## **COLLETON PLACE SUBDIVISION,** **PHASES 2-4**

APPLICATION NUMBER 3 DATE December 4, 2014

REQUEST Subdivison

# DETAIL SITE PLAN

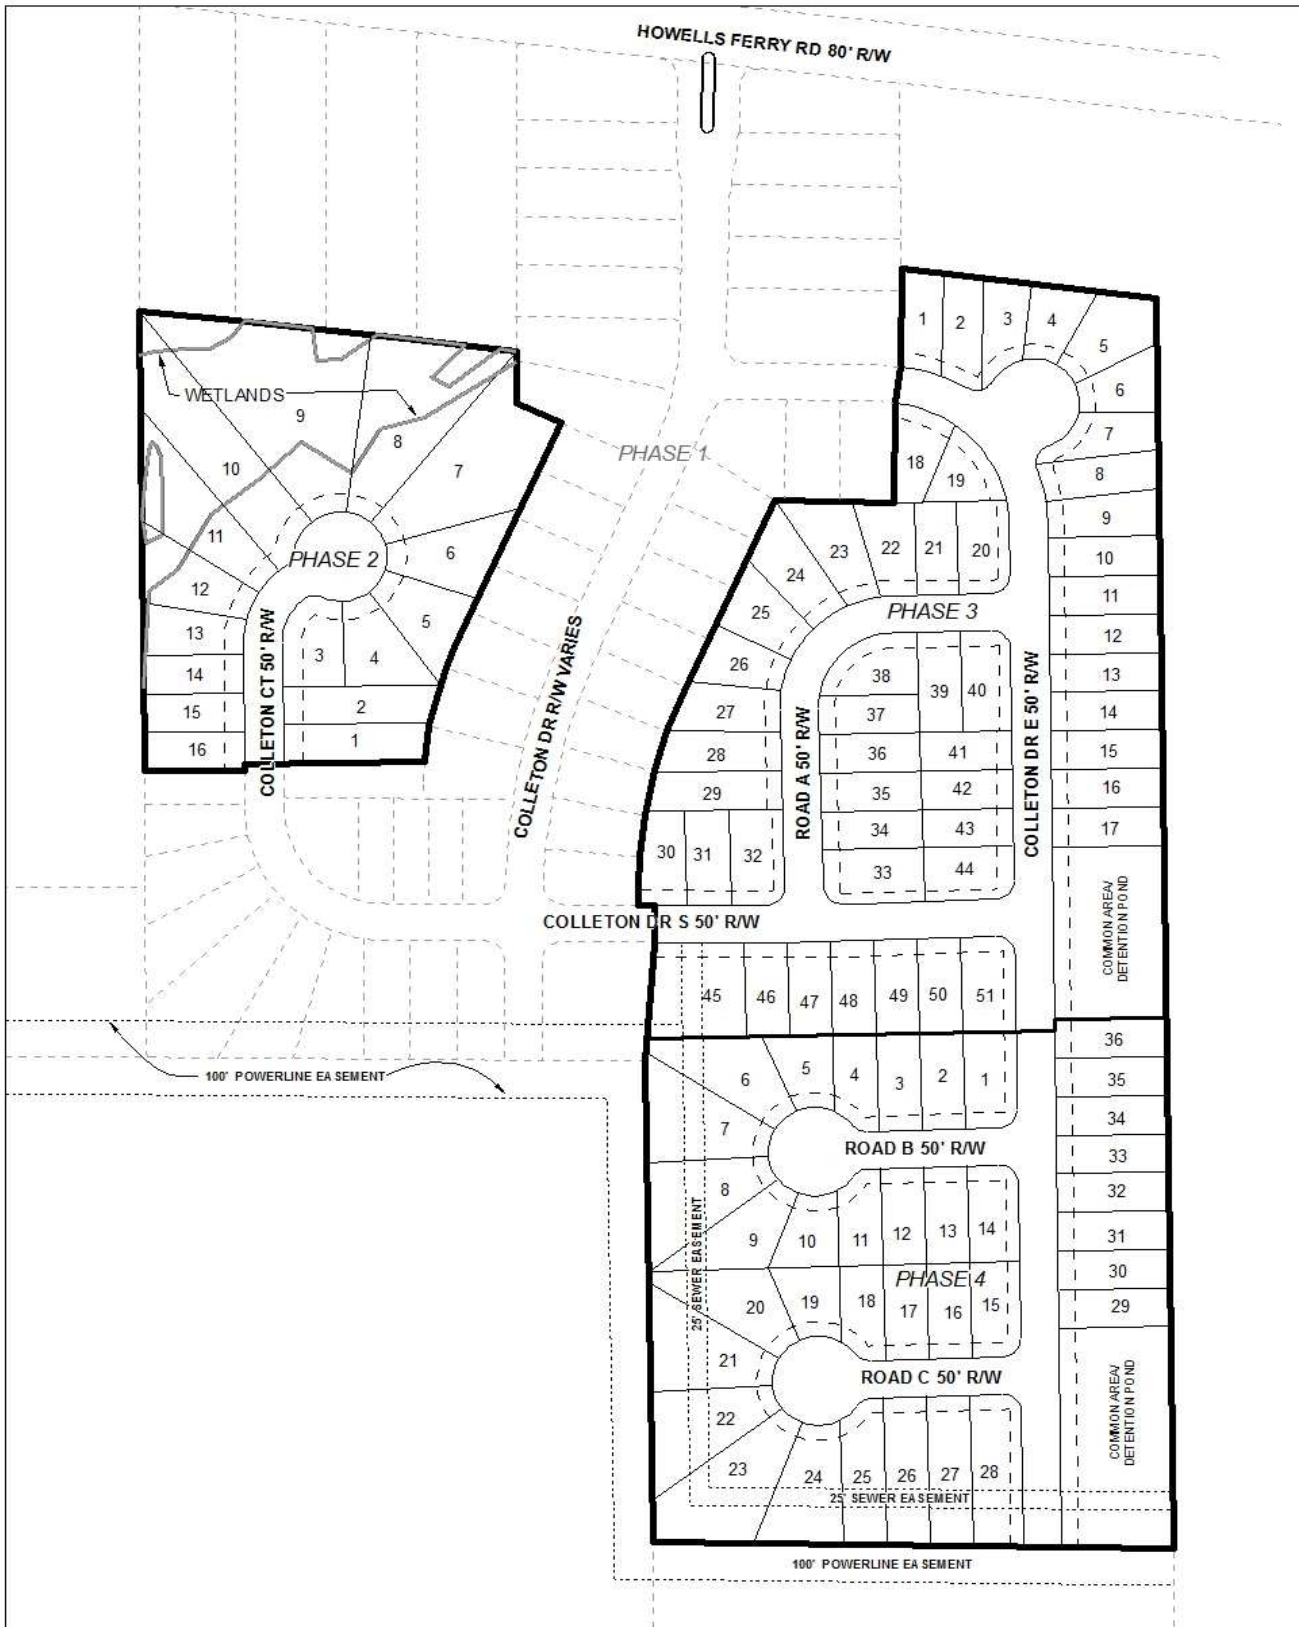
Not all of the proposed lots appear to comply with the minimum lot size requirements of the Subdivision Regulations, as 28 of the overall 104 new lots are proposed to be smaller than 7,200 sf. (the smallest lot would be 6,073 sf.) and, as such, would require a waiver of Section V.D.2. of the Subdivision Regulations for approval. Several lots would also require a waiver of Section V.D.3. of the Subdivision Regulations due to the extreme depth of the lots. The applicant also desires a reduced front yard setback of 20' and a side street setback of 15' – approval would require a waiver of Section V.D.9. of the Subdivision Regulations – citing the approval of Phase 1 as justification for a smaller lot size and reduced front yard setback. It should be pointed out that although a 20' setback is desired, the 16 proposed lots in Phase 2 appear to have a 25' minimum building setback as depicted on the preliminary plat. If approved, the Final Plat should be revised to illustrate the correct setback for all proposed lots.

The right-of-way width of all proposed streets within the subdivision is 50', as compliant with Section V.B.14. of the Subdivision Regulations. The plat also depicts a compliant 120' right-of-way width for all proposed cul-de-sacs; however, if approved, the provision of a temporary turnaround in compliance with Section V.D.6. of the Subdivision Regulations should be required at the terminus of Colleton Drive East prior to the signing of the Final Plat for each phase. All proposed streets must be built to Mobile County Engineering standards and be accepted by Mobile County prior to the signing of the Final Plat.

The applicant is proposing a mailbox kiosk and onsite parking with two curb-cuts for the proposed Lot 45 in Phase 3. As a means of access management, a note should be placed on the Final Plat limiting the proposed Lot 45 in Phase 3 to 2 curb-cuts and all other proposed lots in Phases 2-4 be limited to 1 curb-cut each, with the size, design and location to be approved by Mobile County Engineering and conform to AASHTO standards.

As mentioned previously in this report, the applicant is proposing a mailbox kiosk with onsite parking on the proposed lot 45 in Phase 3. As this site is located in the County, any lots which are developed commercially and adjoin residentially developed property must provide a buffer, in compliance with Section V.A.8. of the Subdivision Regulations. If approved, this note should be placed on the Final Plat along with the illustration of a residential buffer for the proposed Lot 45 in Phase 3 along the southern, western, and eastern lot lines.

Finally, the site is located within the City of Mobile's Fire Jurisdiction. While the existing Colleton Drive provides a stub-out to the South, and while the proposed Colleton Drive East is shown as providing a second stub-out to the South, the overall subdivision will only have one point of access for a total of 153 lots (existing plus proposed) until such time as the adjacent properties are developed.

- 1) The proposed additional phases will increase the number of lots within a subdivision that has only one point of access, thus the development will not comply with Section I.C.2. of the Subdivision Regulations, regarding Health and Safety;*
- 2) The subdivision, as proposed, will not comply with Section DI07.1 of Appendix D, of the 2009 International Fire Code, as adopted by the State Fire Marshal.*

- 1) Revision of the Final Plat to illustrate a 20' minimum building setback for Phase 2 and retention of all other setbacks;
- 2) Retention of the lot size information;

- 3) Provision of a temporary turnaround in compliance with Section V.D.6. of the Subdivision Regulations at the terminus of Colleton Drive East prior to the signing of the Final Plat for each phase;

- 4) Provision of a residential buffer, in compliance with Section V.A.8. of the Subdivision Regulations, along the southern, western and eastern lot lines of Lot 45 in Phase 3;

- 8) Placement of a note on the Final Plat stating that Lot 45 in Phase 3 is limited to 2 curb-cuts, with the size, design and location to be approved by Mobile County Engineering and conform to AASHTO standards;

- 9) Placement of a note on the Final Plat stating that all lots (except Lot 45 in Phase 3) are limited to one curb-cut each, with the size, design and location to be approved by Mobile County Engineering and conform to AASHTO standards;
